TENNESSEE VALLEY AUTHORITY  
KNOXVILLE, TENNESSEE 37902

WATTS BAR NUCLEAR PLANT (WBN) - NPDES PERMIT NO. TN0020168 -  
COMPLIANCE EVALUATION INSPECTION REPORT AND NOTICE OF VIOLATION

## ENCLOSURE 1

## DIFFUSER pH STUDY

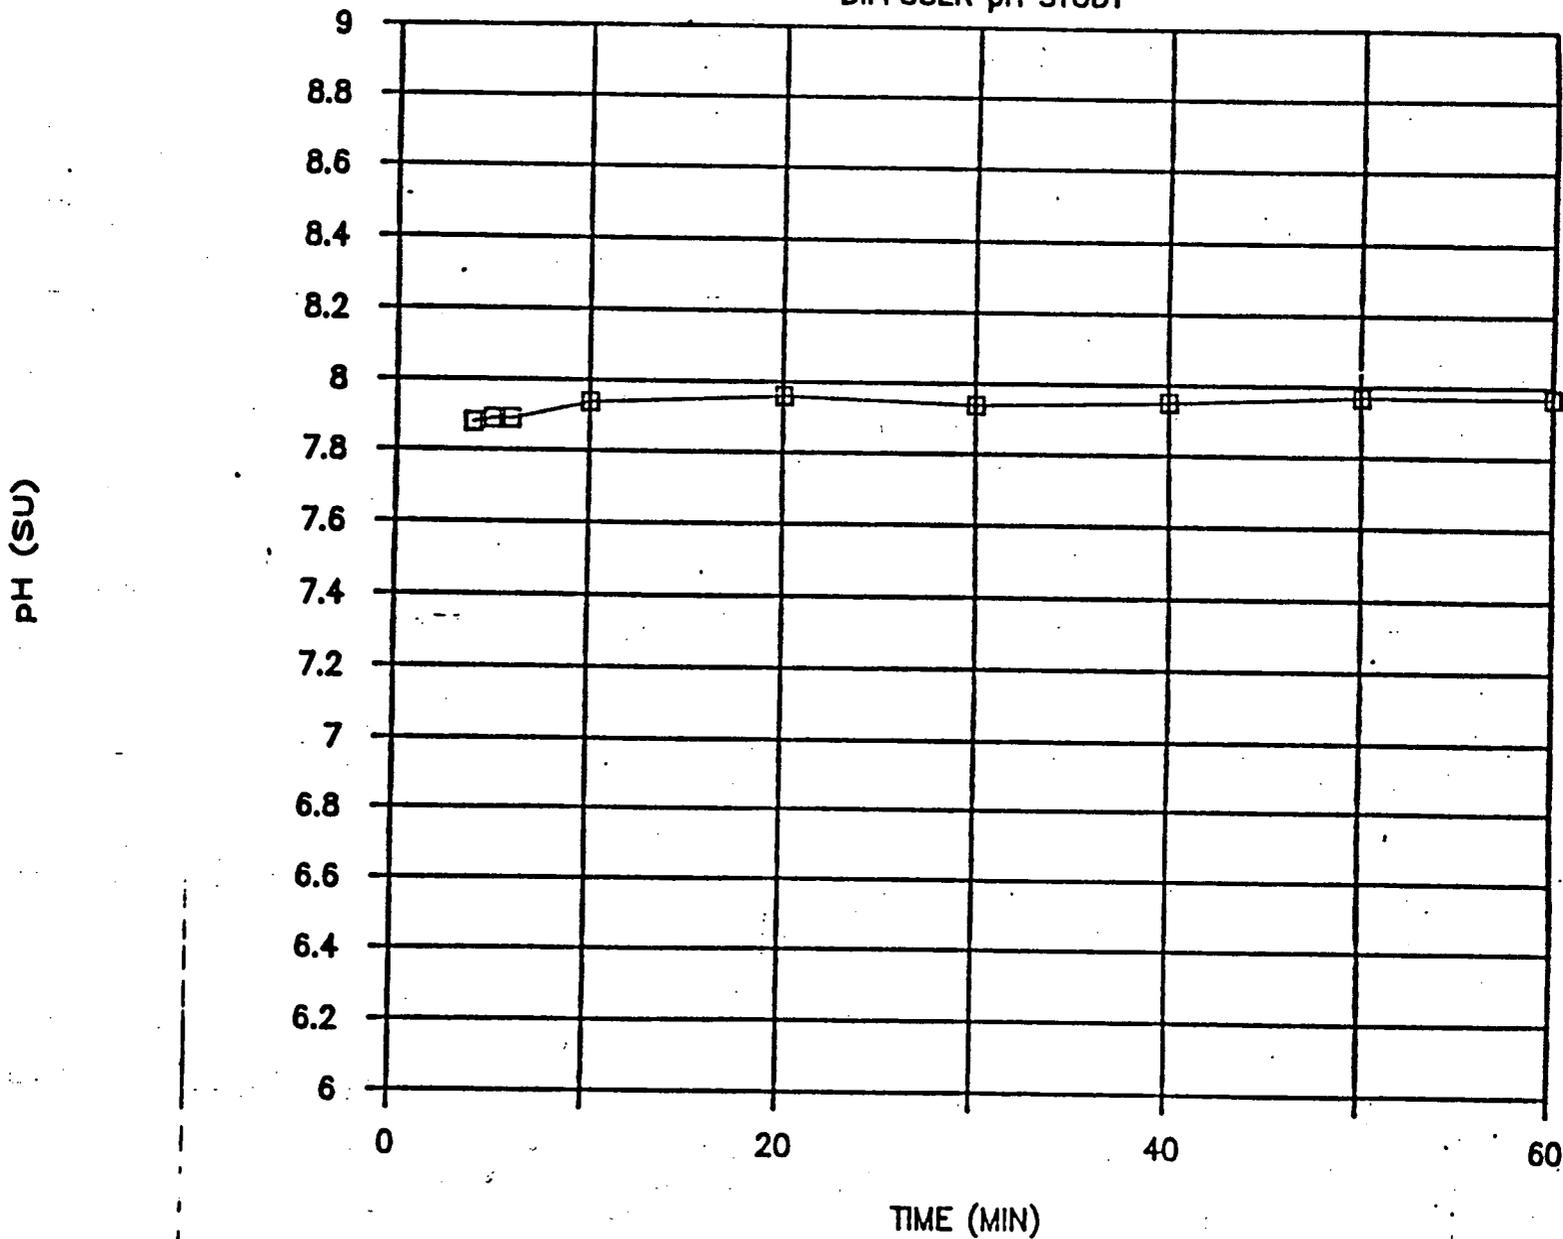
### Notice of Violation 4 - In-field versus Laboratory pH Measurements

WBN plans to pursue the use of laboratory pH measurements. The chemistry staff conducted studies to determine the effect of temperature and time on pH measurements. The results of these studies are attached in graphical form. For the time studies, a pH meter was installed in the portable building near the ponds. The time for analyses are indicated on the graphs. Samples were taken in polyethylene bottles and sealed until pH measurements were performed. The temperature studies were made in the laboratory using a water bath with the samples in sealed polyethylene bottles. Standard Methods for the Examination of Water and Wastewater, 16th Edition, 1985, Method 423, pH values, states that  $\pm 0.1$  pH units represents the required limit of accuracy, and values should be reported within  $\pm 0.1$  pH units. The studies conducted show that the pH values did not vary more than  $\pm 0.1$  pH units over the range of temperatures and times used in the studies. The samples are routinely sealed in one-liter poly bottles until pH measurements are performed. Based upon your review of this information, please advise TVA if a formal variance is required.
